Preservation Department – Item 4, LPC-26-09292

**500 Fifth Avenue – 500 Fifth Avenue Building – Individual
Landmark – Borough of Manhattan**

Questions and Answers for 7/28 LPC Public Hearing

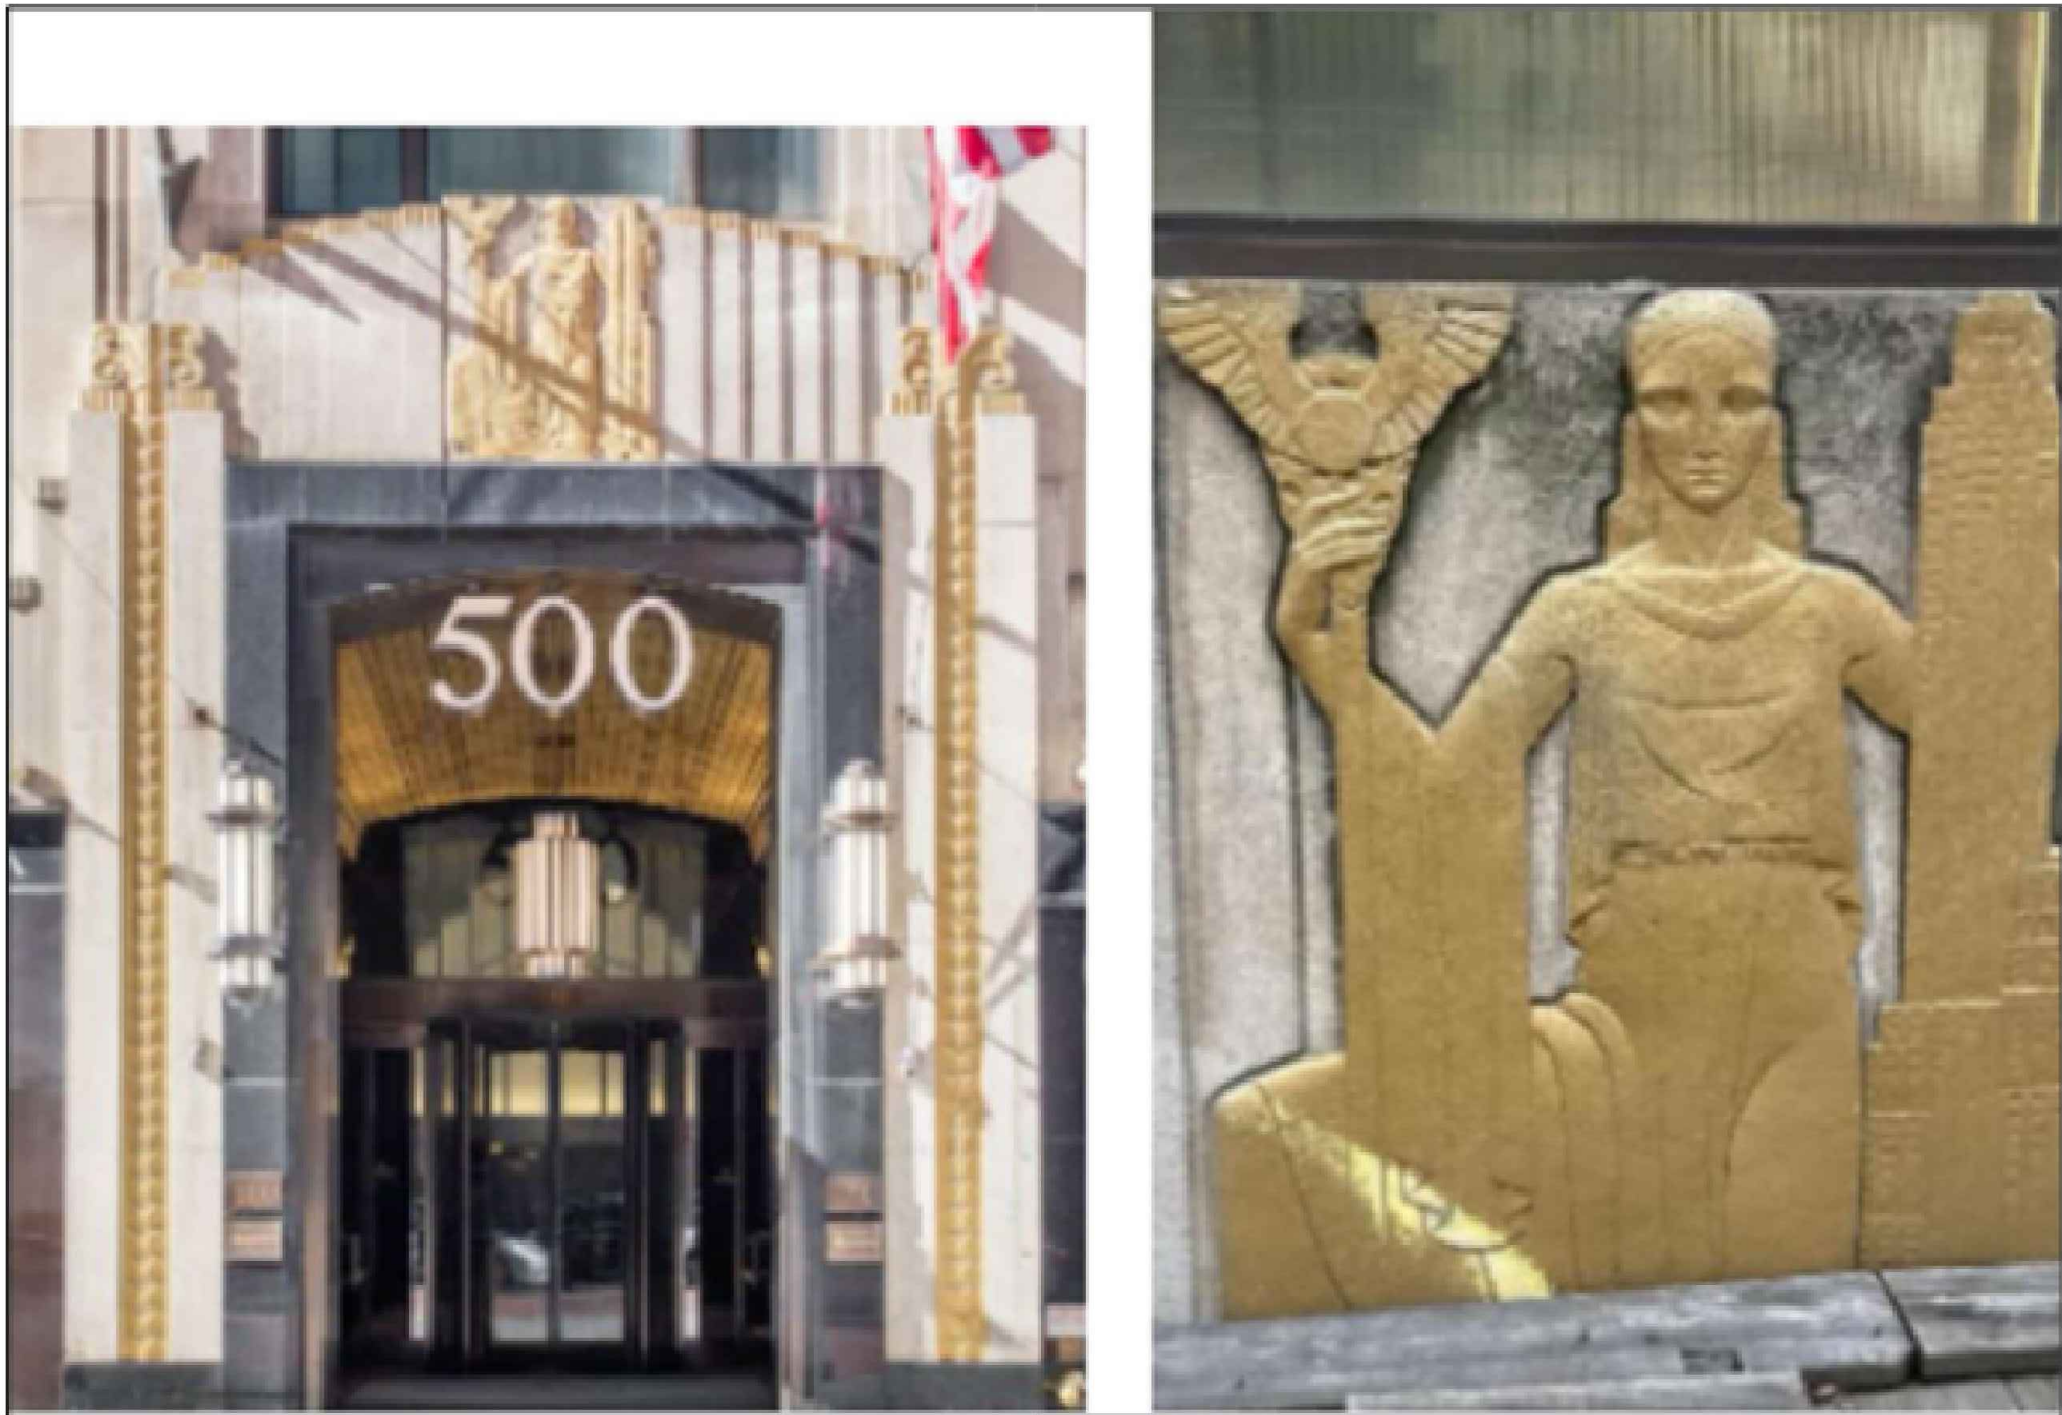
4. Provide photos of current entry condition. Cannot be seen with scaffold in the way.

*** As requested, please see the photos below and attached herewith of **current entry conditions** obstructed from view by the scaffold. These photographs illustrate the existing condition of the entrance, including the current gilded figurine, crowns, and architectural features that form the basis of this application.

1 SIMILAR EXAMPLES OF EXTERIOR GILDING ON DECORATIVE ELEMENTS
SCALE: NTS

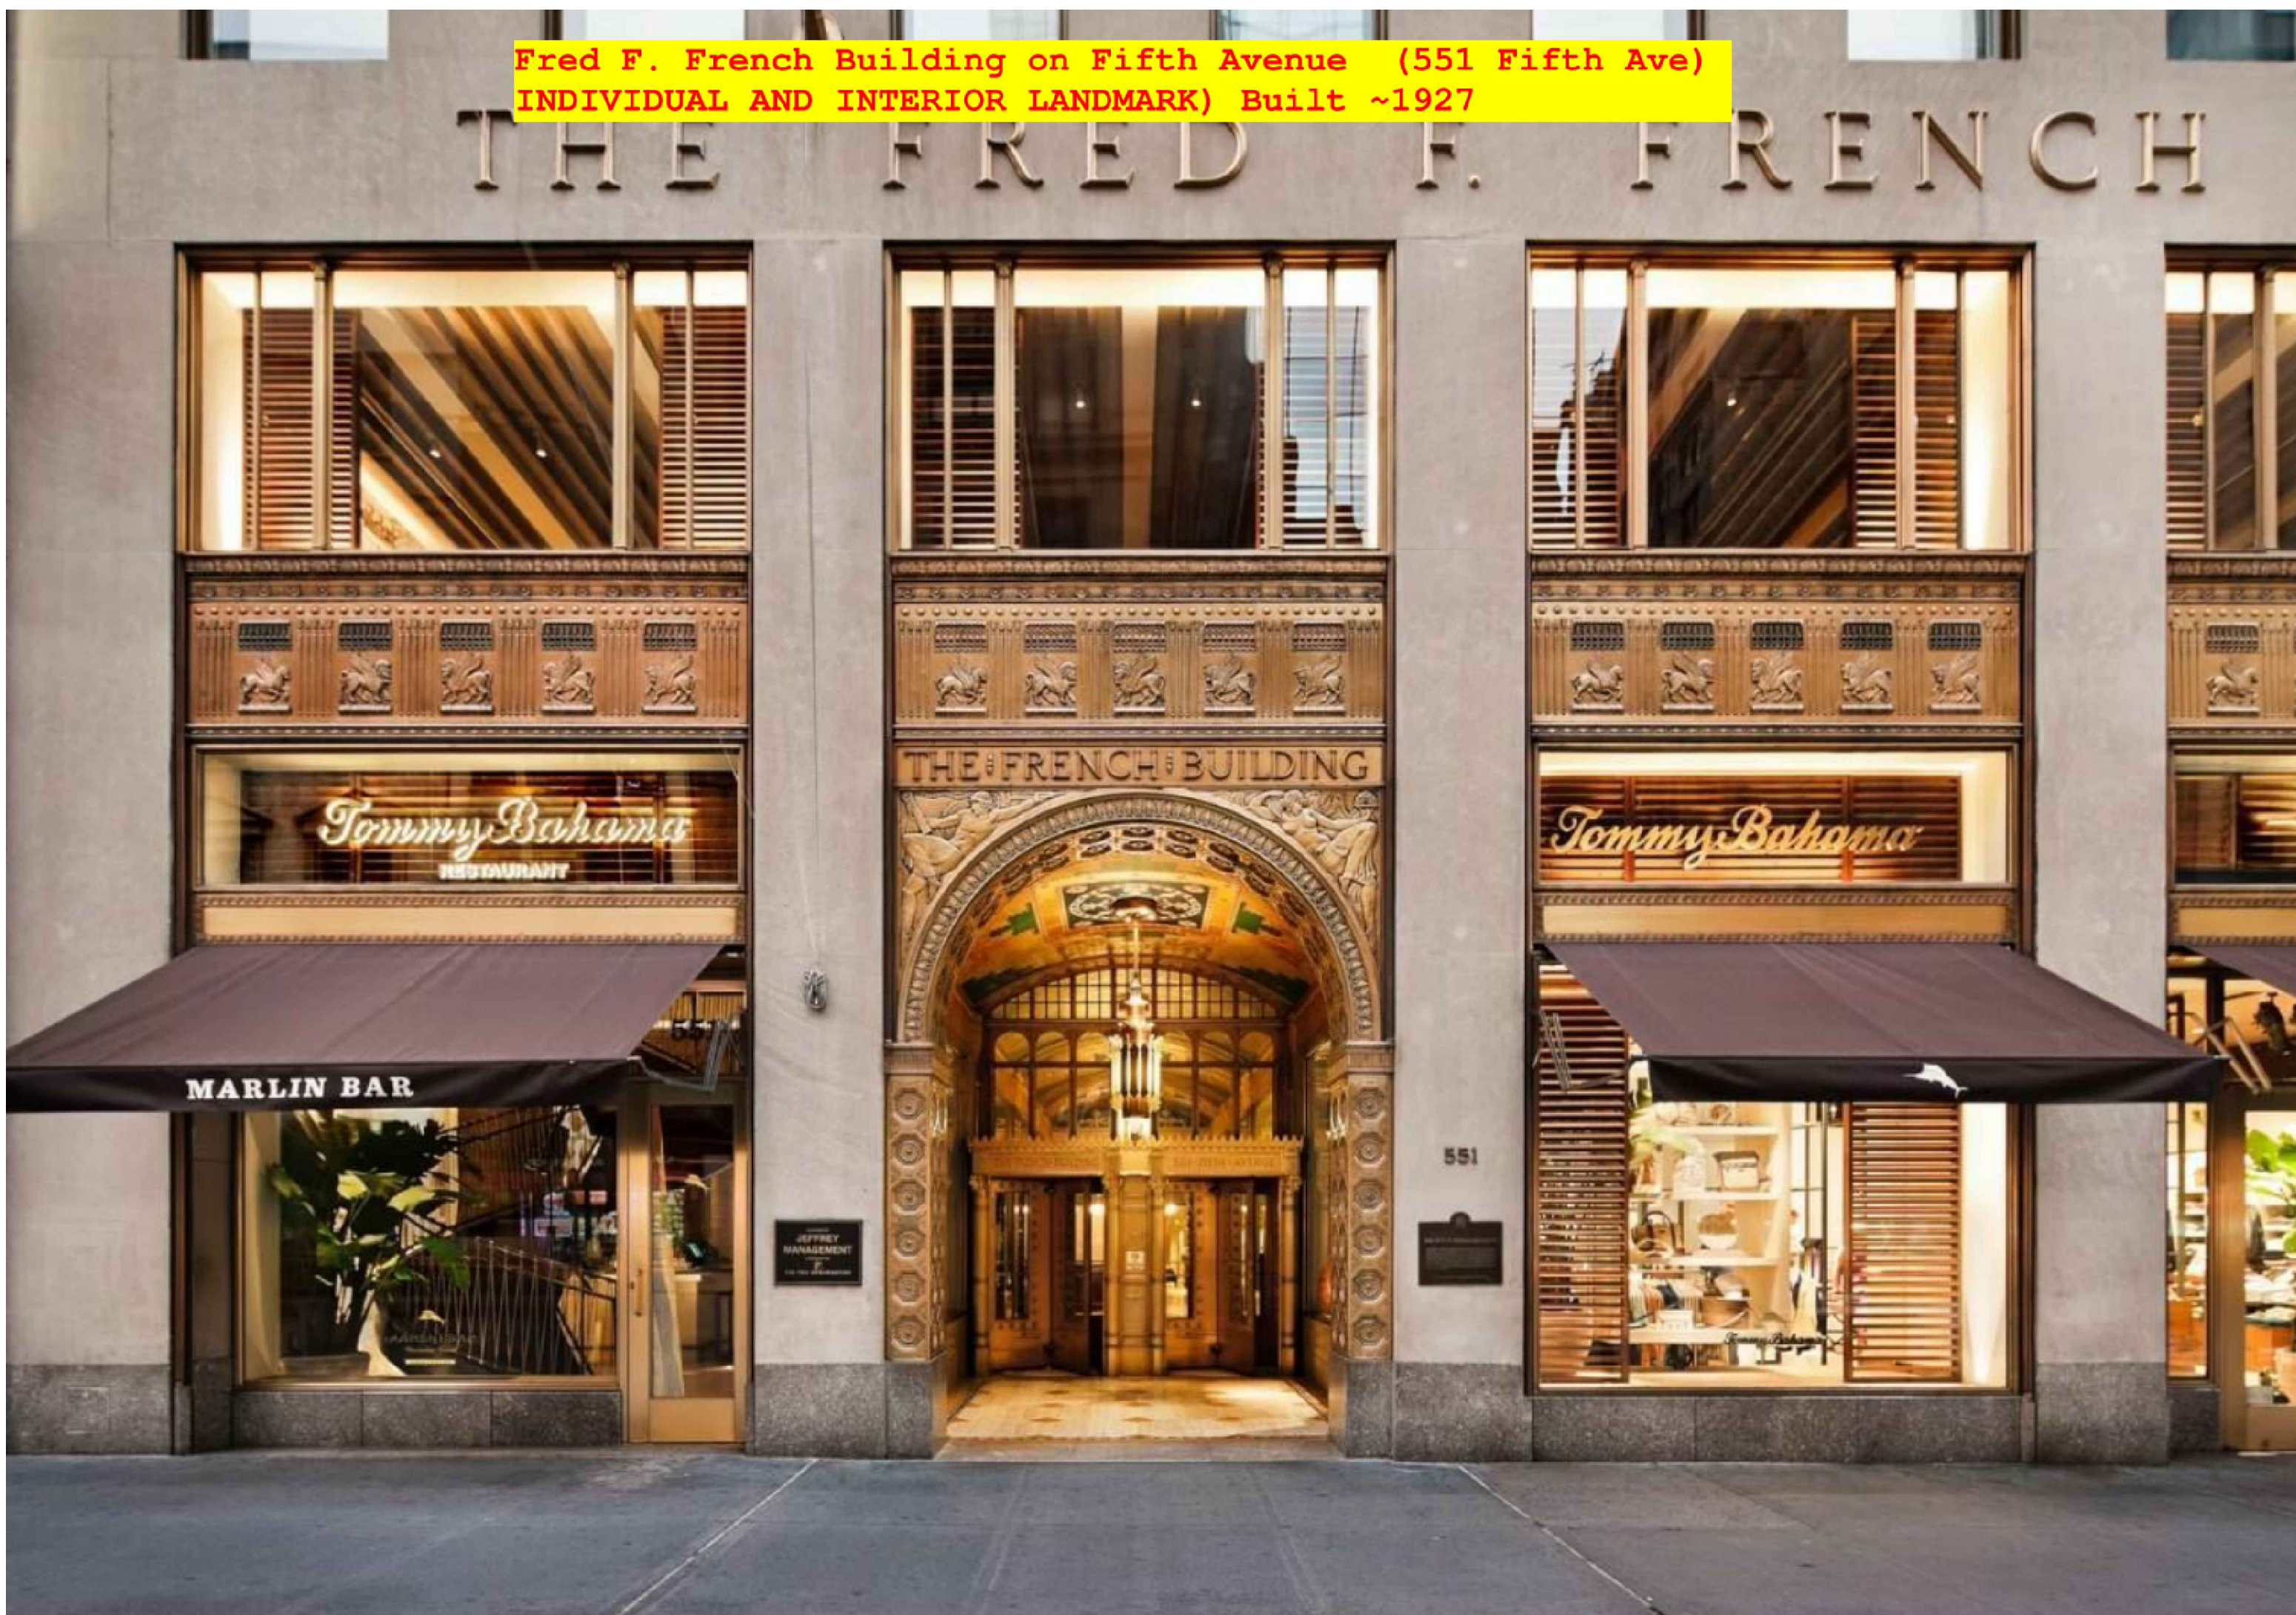
2. Any precedent of other buildings or individual landmarks that have had existing features painted gold?

*** The use of gold as an exterior architectural finish is well established among prominent Art Deco buildings from the same era.

As examples, the **Empire State Building** (20 West 34th Street, INDIVIDUAL AND INTERIOR LANDMARK), completed during the same period and designed by the same Designers, Shreve Lamb & Harmon, incorporates a gilded exterior as a defining architectural feature.

Similarly, the **Fred F. French Building on Fifth Avenue** (551 Fifth Ave, INDIVIDUAL AND INTERIOR LANDMARK), prominently uses gilded architecture on its façade. Please see the photo below and attached for reference:
